NINE MILE POINT NUCLEAR STATION, UNIT NO. 1

AMENDMENT TO FACILITY OPERATING LICENSE

Amendment No. 44
License No. DPR-63

SAFETY EVALUATION BY THE OFFICE OF NUCLEAR REACTOR REGULATION

FIGURE 1

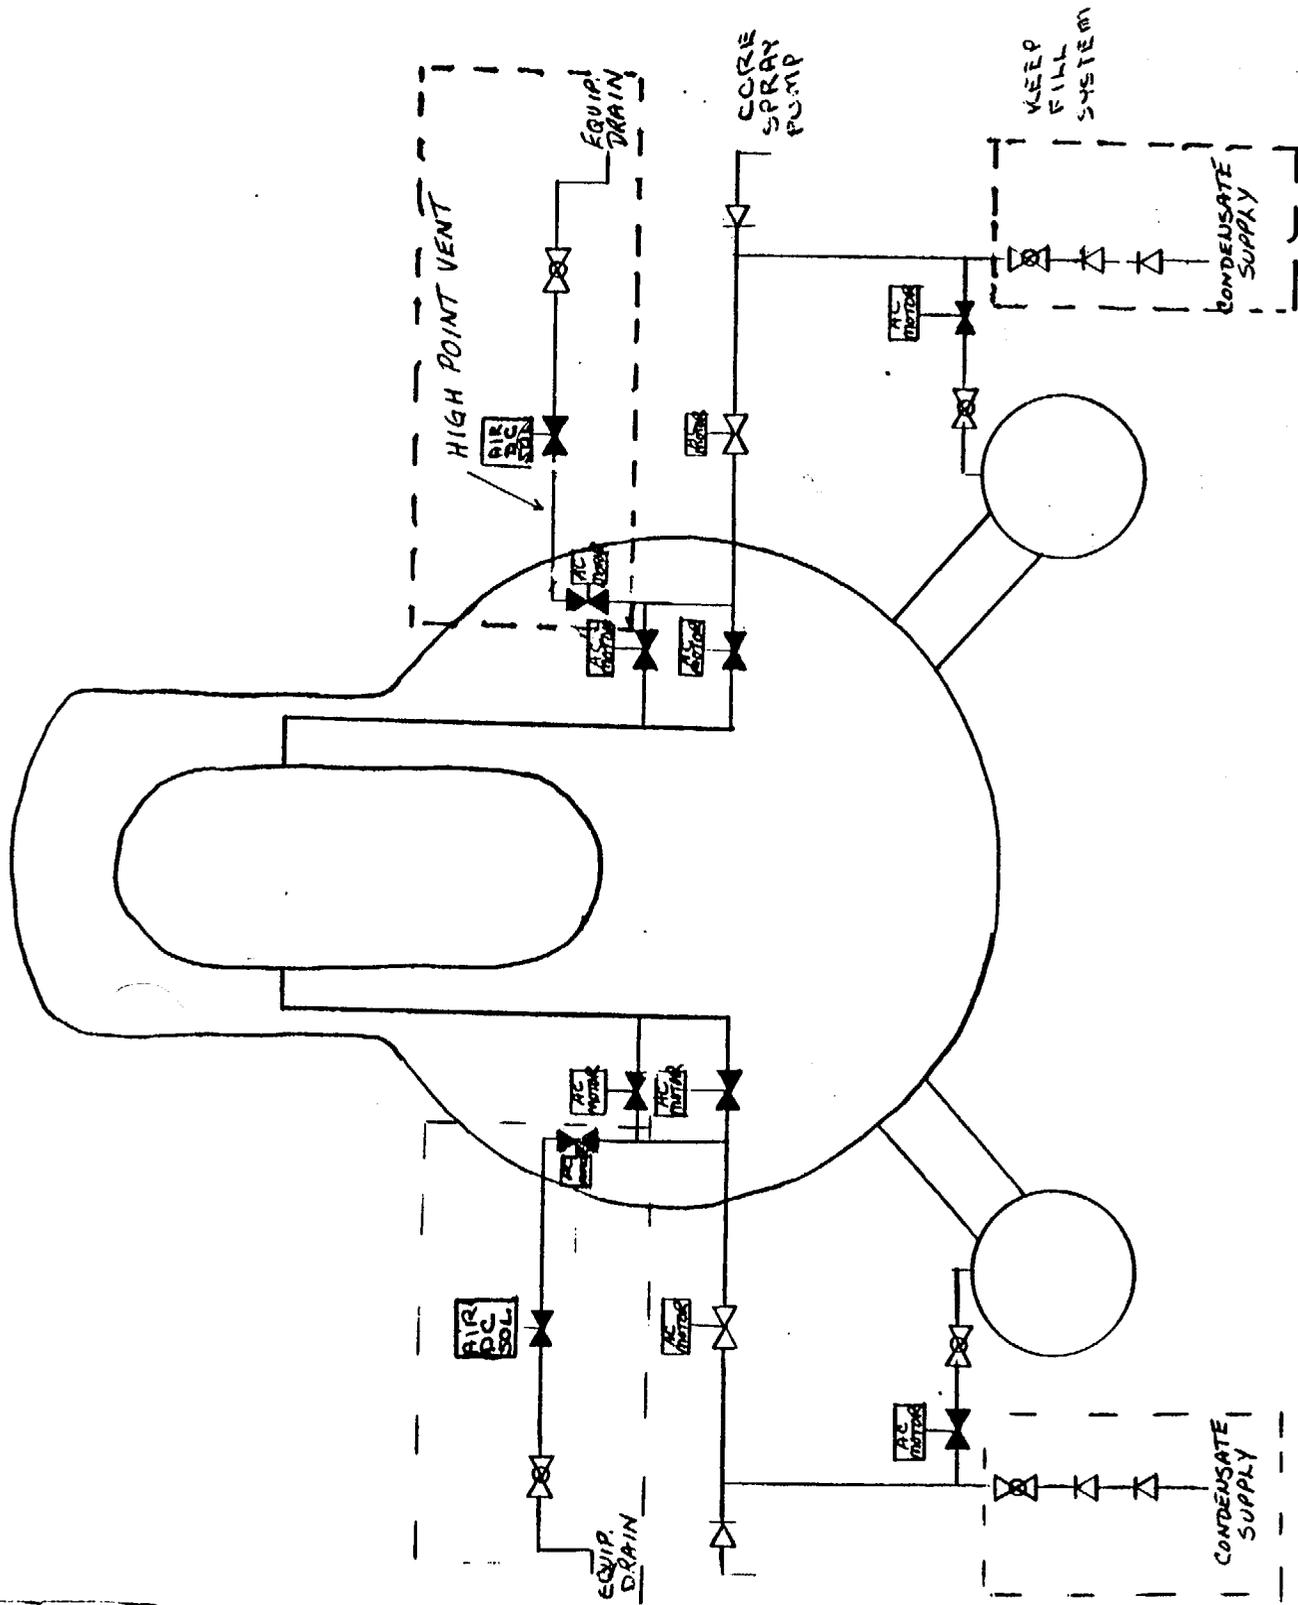
By letter dated March 2, 1981, Niagara Mohawk Power Corporation (licensee) proposed changes to the Technical Specifications to modify the Core Spray System. The Nine Mile Point Core Spray/High Point Vent System is shown on the attached figure. The proposed modifications are shown by the dashed lines.

Prior to the modifications, the core spray line had a stop check valve and a locked open motor operated valve (MOV) outside containment and two normally closed MOVs in parallel inside containment. ASME Section XI (Inservice Testing) requires periodic testing of the core spray pump and exercising of the motor operated valves. The licensee's operational experience showed that due to elevation differences, the core spray piping outside the drywell would drain. Whenever the core spray pump was started or the inside MOVs were exercised, a water hammer would develop as water filled the drained pipe.

Due to the drainage and potential water hammer problem, the licensee would have to shutdown before performing the quarterly valve operability test. Primary system pressure would have to be lowered sufficiently so that the inside MOVs could be exercised without causing water hammer in the core spray piping.

The licensee's letter of March 2, 1981 (reference 1) proposed installing a keep-fill system, a high point vent, and associated containment piping, valves and control circuitry. The keep-fill system maintains a water inventory in the core spray piping during normal operation. This system should prevent any water hammer if the core spray system were actuated. The high point vent penetrates the primary containment and leads to the equipment drain tank. The two valves of the high point vent are containment isolation valves and are normally closed. Prior to any ASME Section XI testing, the valves are opened until water comes out the equipment drain. When water comes out the drain, this signifies that any air in the piping has been purged. The valves are then closed and Section XI testing begins.

The keep-fill system uses water from the condensate supply to maintain a water inventory in the core spray piping. The stop check valves and downstream piping were designed to ASME Section III, Safety Class 2. The pressure rating of the check valves is equivalent to system pressure (1200 psig). The keep-fill system will be beneficial in that it will provide a constant head on the core spray pump discharge check valve thus preventing movement of its disk.

The high point vent system will also be designed to ASME Section III, Safety Class 2. Both the inside motor operated valve and the outside air operated valve are normally closed and receive automatic isolation signals upon low-low reactor water level or high drywell pressure. Both valves will be subject to local leak rate testing per Appendix J to 10 CFR Part 50 and periodic exercising per ASME Section XI.

The licensee has agreed to Technical Specifications to periodically (at least monthly) open the high point vent valves and verify that the keep-fill system is maintaining the piping volume full of water. This will provide additional assurance that the operability of the core spray system will not be degraded due to water hammer. The licensee has also implemented Technical Specifications governing Reactor Coolant System Isolation Valves. (Reference 2).

The addition of the keep-fill system and the high point vent should prevent water hammer and permit ASME Section XI testing without shutting the facility down. We have reviewed the design criteria of the systems and find them acceptable. Based upon our review of the licensee's submittal we find both the proposed modifications and the associated revision to the Technical Specifications to be acceptable.
